CITY OF ALBUQUERQUE

RE: **Bosque Antigua
Gabaldon Dr NW
Grading Plan Stamp Date: 8/27/18
Drainage Report Stamp Date: 8/27/18
Hydrology File: J12D015**

Based on the submittal received on 8/27/18 the above-referenced submittal is approved for Preliminary Plat Only. J12D015 is the correct file number for this project; the previous letter heading was incorrect.

RE: **Bosque Antigua
Gabaldon Dr NW
Grading and Drainage Plan
Engineer's Stamp Date 6/26/18
Hydrology File: G11D071**

Date:	No. Revision:	Date:	Job No.
08/26/18			2273
Drawn By:	JTS		CG-101
Ckd By:	ANW		SH OF

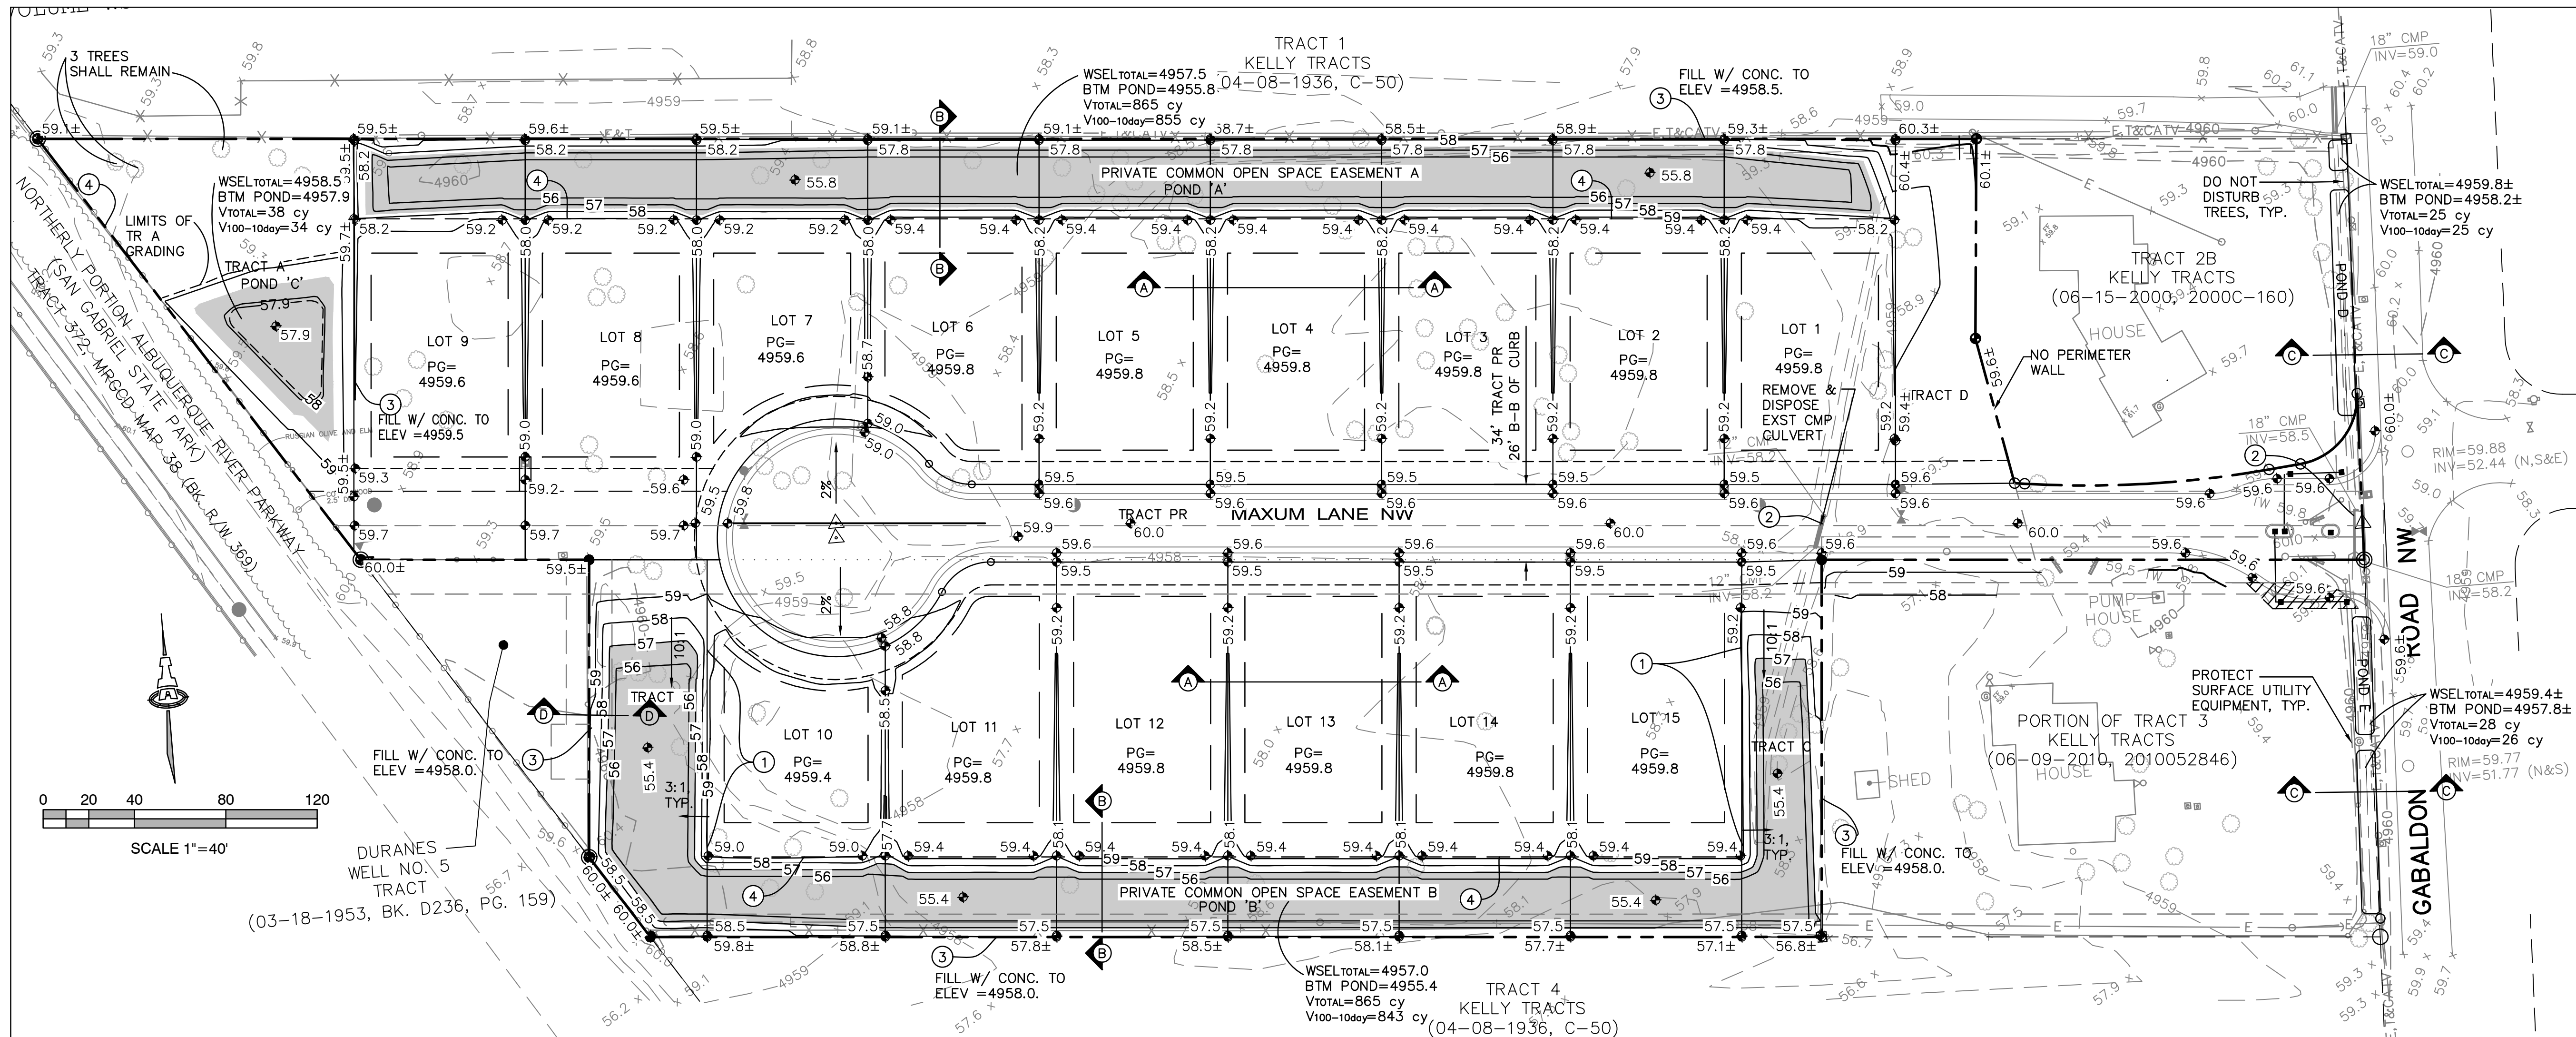
1. Pond A WSE is shown as 4957.5', but described in the drainage report as 4957.0'. Pond B WSE is shown as 4957.0', but described in the drainage report as 4957.5'. Pond B capacity is shown as 865cy, but described in the drainage report as 876cy Please correct.
2. This project requires an ESC Plan, submitted to the Stormwater Quality Engineer (Curtis Cherne PE, ccherne@cabq.gov or 924-3420).

SECTION B-B
NTS

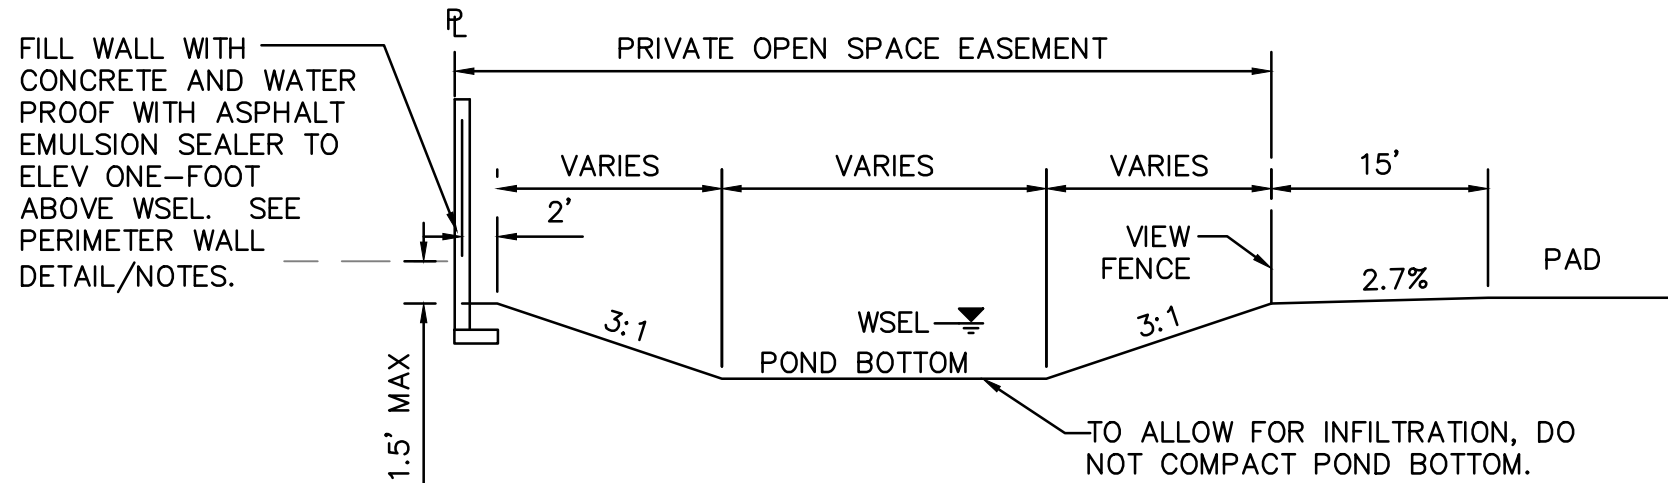
6. Section B-B shows a new garden wall on the property line. Either inset all new walls (and their footers) from the property lines or provide written and signed permission from the neighbor for the encroachment.

6. A perimeter wall detail was added along with notes stating that wall will need to be constructed on this property, including footings, unless written permission from adjacent property owner is obtained to construct wall on property line.
